Town of Parker Community Development Department
 Development Review Division
 Attention: ~~Carson Byerhof~~ *Ashley Chasez*

Application Type: **Site Plan**
 Status: **First Referral**
 Application Name: Douglas 234 F6 AMD 1 L4 - Dunkin Donuts
 Case/AP#: **SP22-041**
 Referral Received: June 13, 2022
 Comments Due: July 13, 2022

TOWN OF PARKER FIRE/LIFE SAFETY:	R REVIEWED FOR CODE COMPLIANCE; REVISIONS REQUIRED
---	---

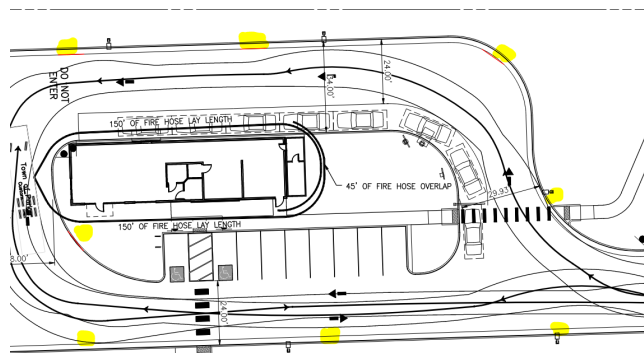
This submittal does not provide for this requirement of the code. Per the requirements of the code, the fire code official is allowed to increase the dimension of the 150 feet provided that the applicant meets Exception 1.1 of this

section... “The building is equipped throughout with an approved automatic sprinkler suppression system installed in accordance with section 903.1.1, 903.1.2, or 903.3.1.3. The applicant will need to address this issue when resubmitting.

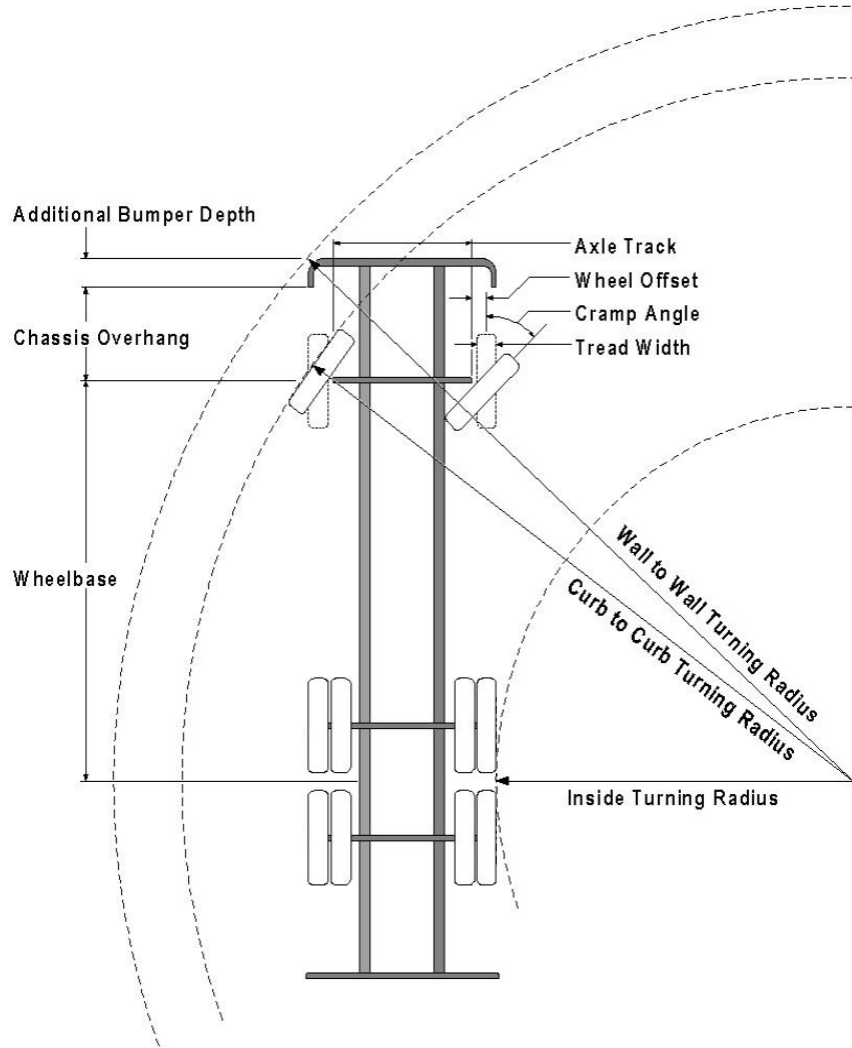
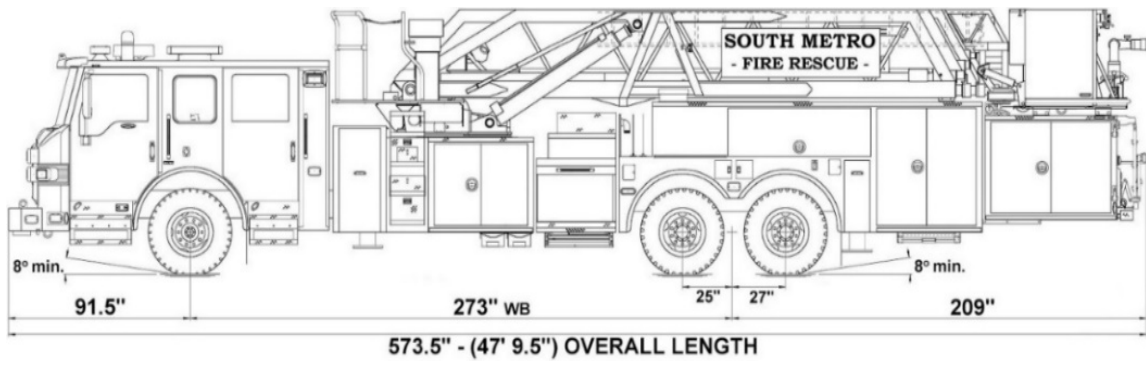
5. The applicant shall provide NO PARKING – FIRE LANE signage for any portion of the access where the 24-foot clear width requirement cannot be met; areas that are required to have this signage are located on both the north and sides of the building. See below for areas highlighted in yellow: **Not satisfied; see below for locations specific to NO PARKING – FIRE LANE signage. Provided double arrows in all cases and address when resubmitting:**
